DELTA CONSULTING & ENGINEERING  
OF ST. HELENA

TRANSMITTAL SHEET

TO:	Mary Doyle	FROM:	Kristi Wagner
COMPANY:	Napa County Planning Department	DATE:	05/15/09
ADDRESS:		DELIVERED VIA:	Hand
PROJECT:	H-125 Lake Ridge Winey Use Permit

Re: Incomplete Memorandum for Use Permit Review  
Lake Ridge Winery  
90 Long Ranch Road, St. Helena, APN 032-010-068  
P09-00039

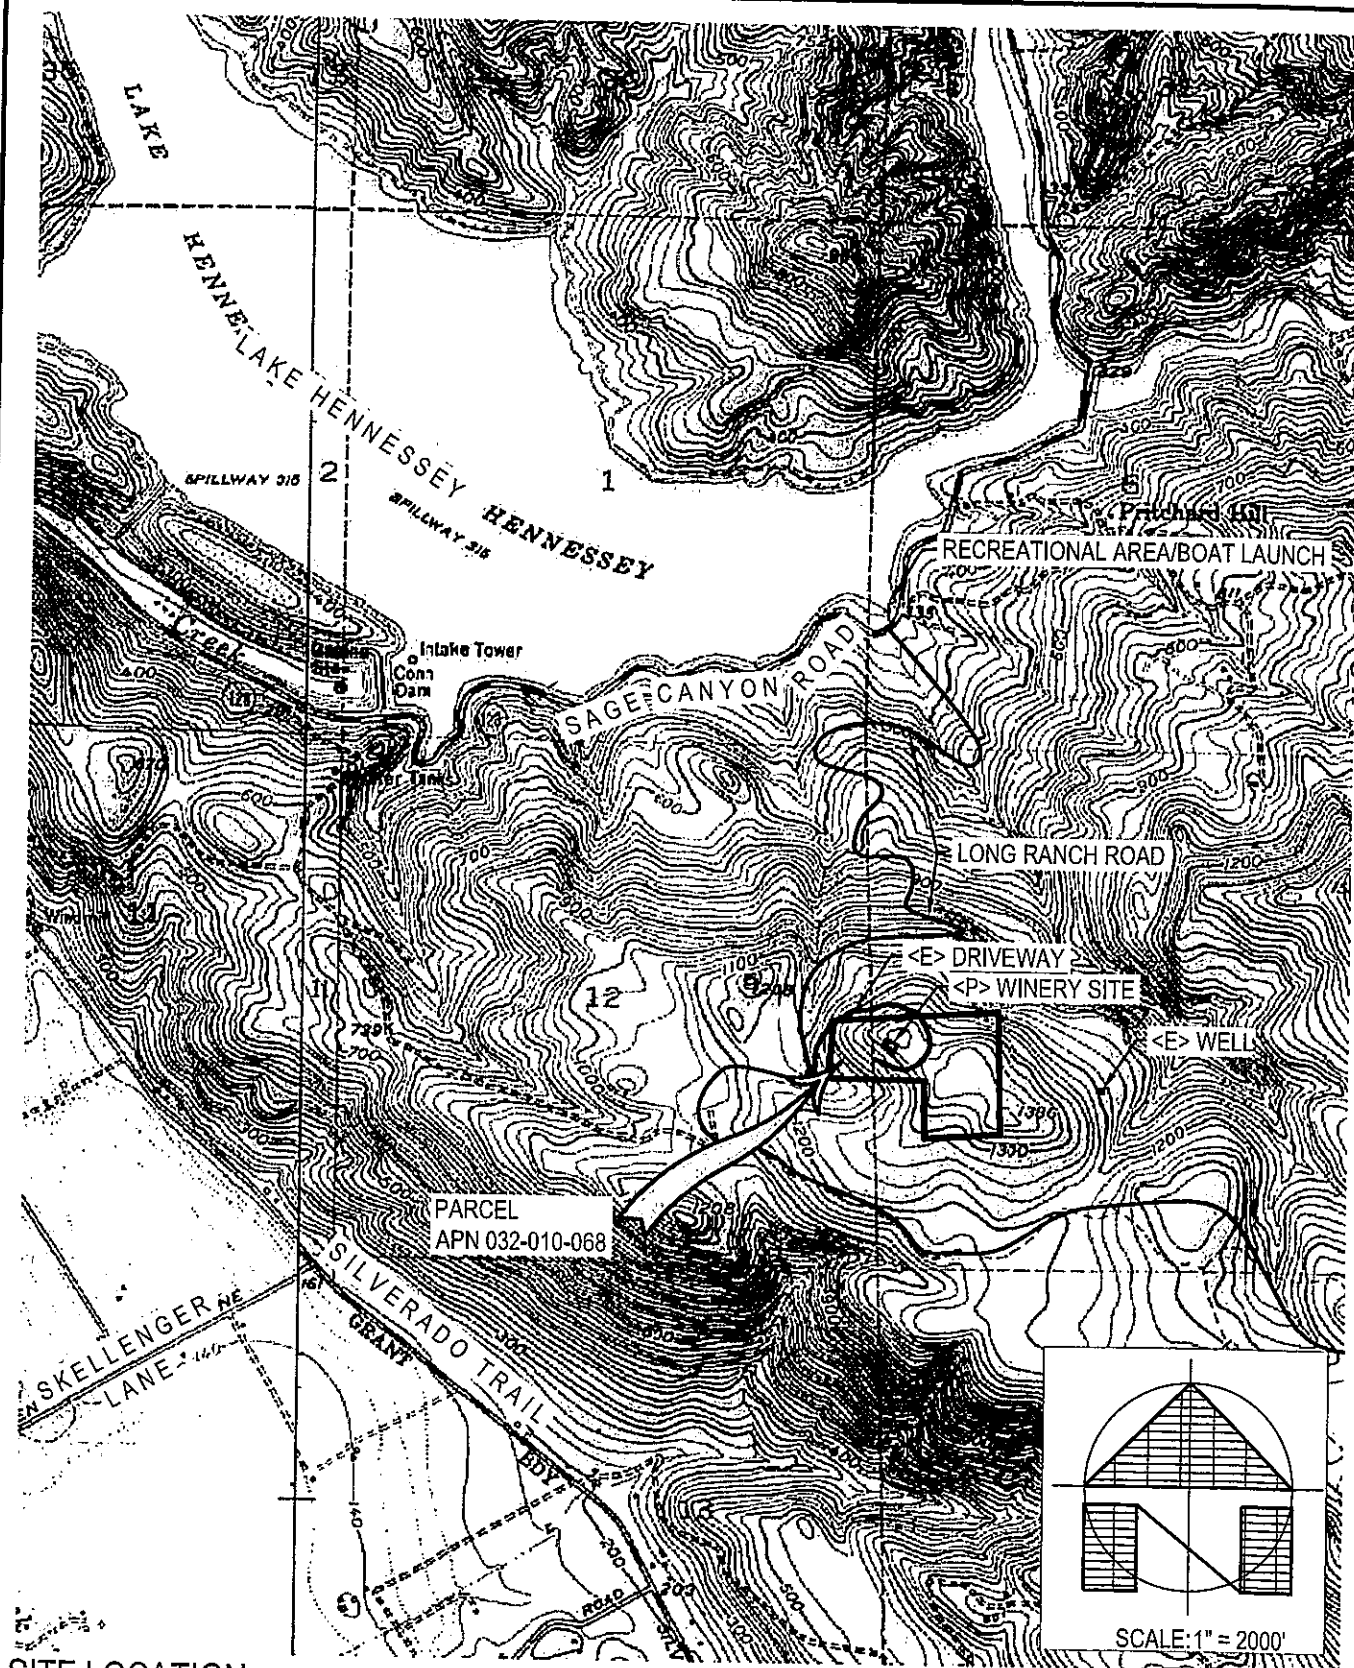
- a. As shown on the Hydrology Exhibit which follows, the area of runoff to the site is from the nearby hill. Four watershed areas considered for this project. The runoff to Watersheds 1, 2 and 3 flow to the existing roadside swale along the driveway that accesses the site. The runoff to Watersheds 2 and 3 will remain unchanged. The runoff to Watershed 1 shall increase due to the proposed winery development. The runoff to watershed 4, approximately 0.4 acres, shall reach the winery site.
- b. The historic drainage patterns of this site will not be changed. No existing surrounding or neighboring developments shall be affected by the proposed winery development.

- a. For this preliminary design, drop inlets and area drains were designed to collect the storm water at the winery site. A combination of a swales and drop inlets behind the winery shall also be used to collect the runoff from Watershed 4. The access driveway and a portion of the service road shall sheet flow into the

This hydrology report concludes that the existing swale of Watershed 1 and the preliminary storm drain system of the winery site is sufficient to contain the runoff of a 10-year storm.

The existing swale of Watershed 1 is on average 4 feet wide and 1 foot deep. This swale shall be sufficient to carry the current runoff of 6.6 cfs and the additional runoff of 1.5 cfs that will be added to this watershed due to the proposed winery development and Watershed 4.

The storm drain system shall use a minimum of a 6" diameter PVC pipe for collection of the runoff from the winery site up to 0.7 cfs. As the total runoff for the winery site and Watershed 4 is 1.5 cfs, the pipe shall be increased to a minimum of 8" diameter, as needed when the combined flow increases above 0.7 cfs.

The pre-construction flow for the winery site is 0.66 cfs, whereas the post-construction flow is 1.0 cfs. The difference of 0.34 cfs will be detained on-site. Hydrographs were prepared for the pre- and post-conditions. The difference in volume is 315 cu ft or 2400 gallons. A 2500 gallons storage tank will be provided on-site for detention.

LAKE RIDGE WINERY  
HYDROLOGY EXHIBIT  
ST. HELENA  
CALIFORNIA

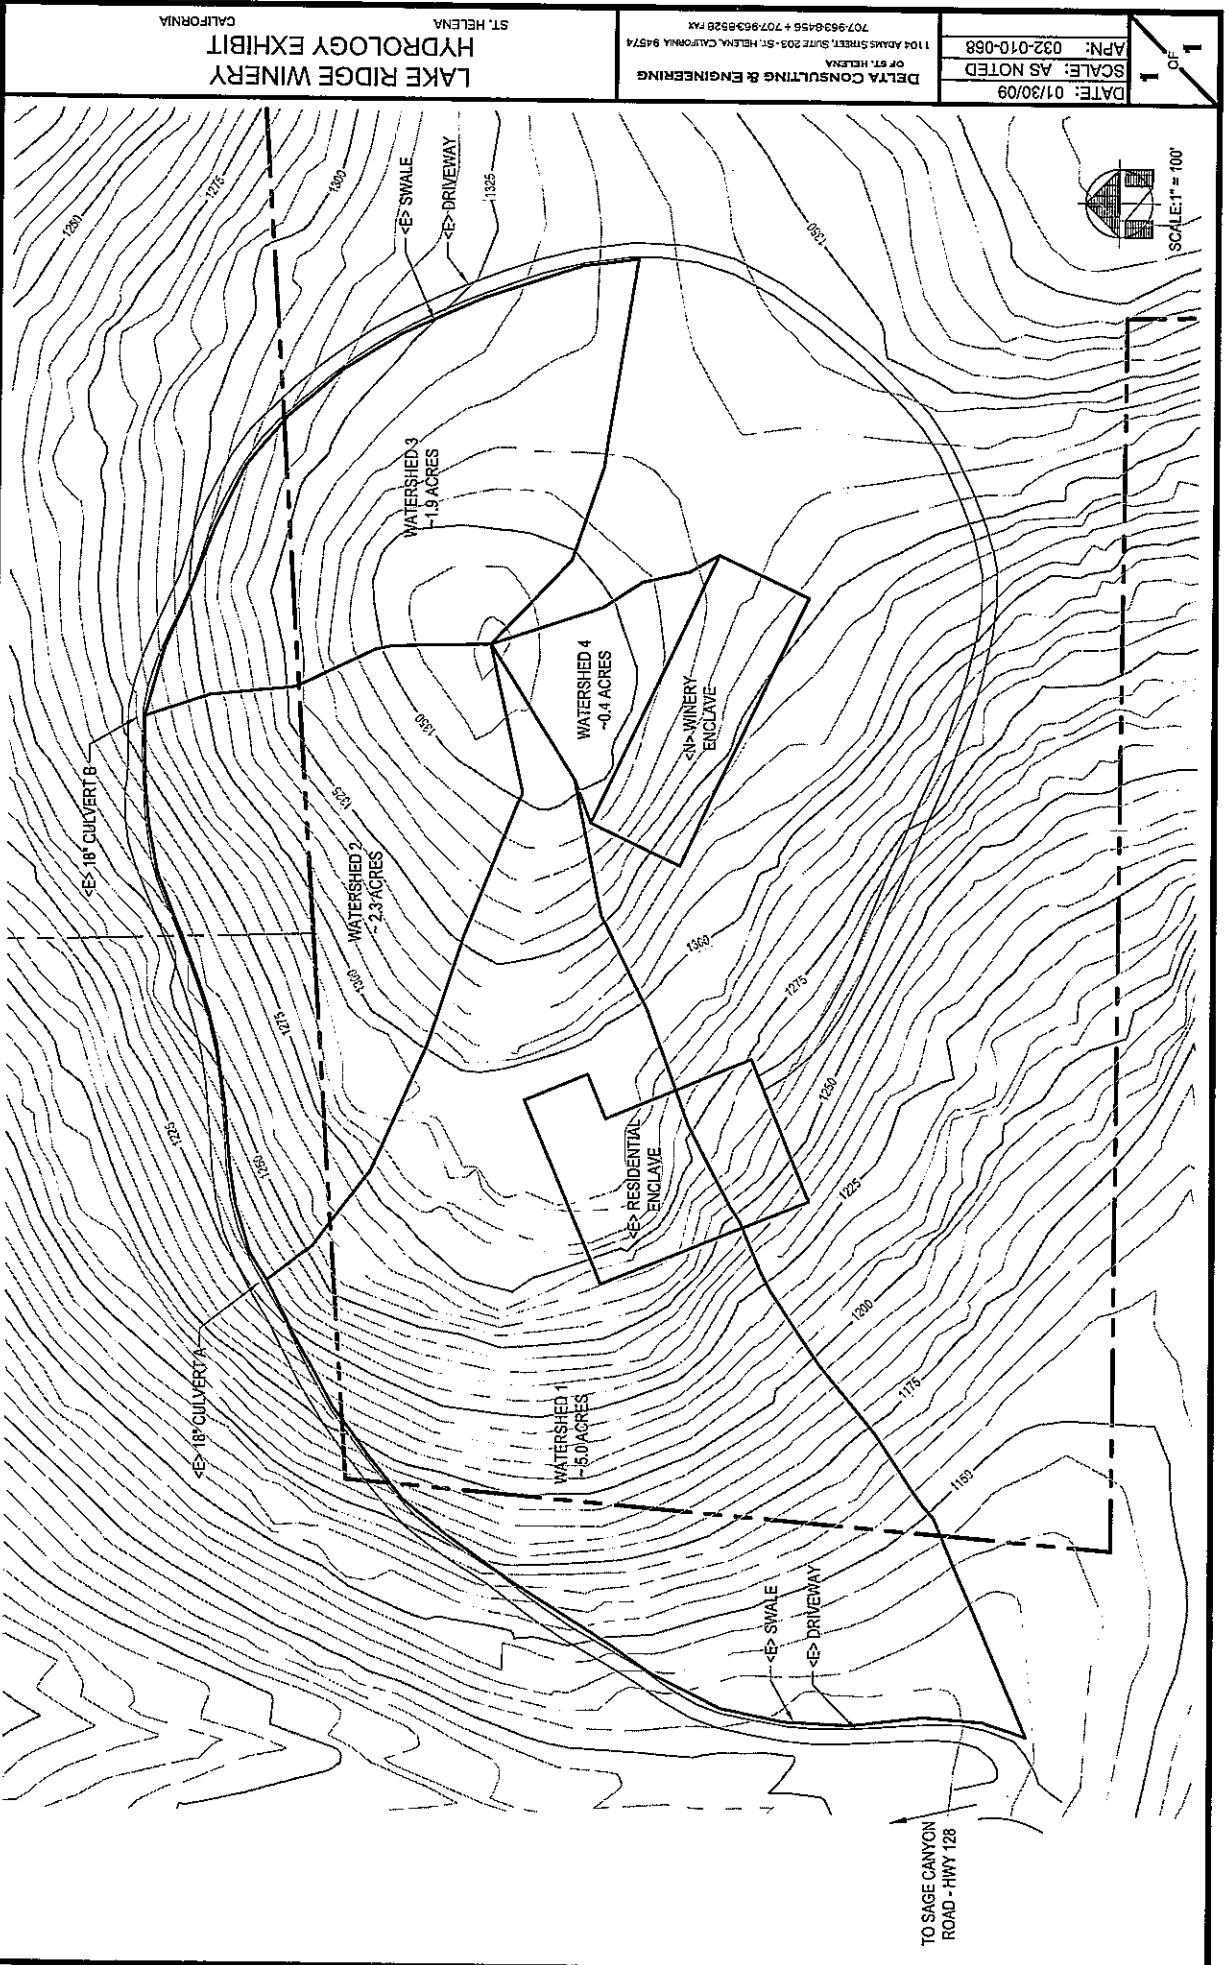
3. Please find included a site hydrology map and preliminary drainage study, dated May 14, 2009 which includes a brief discussion of the historic drainage patterns of the site.
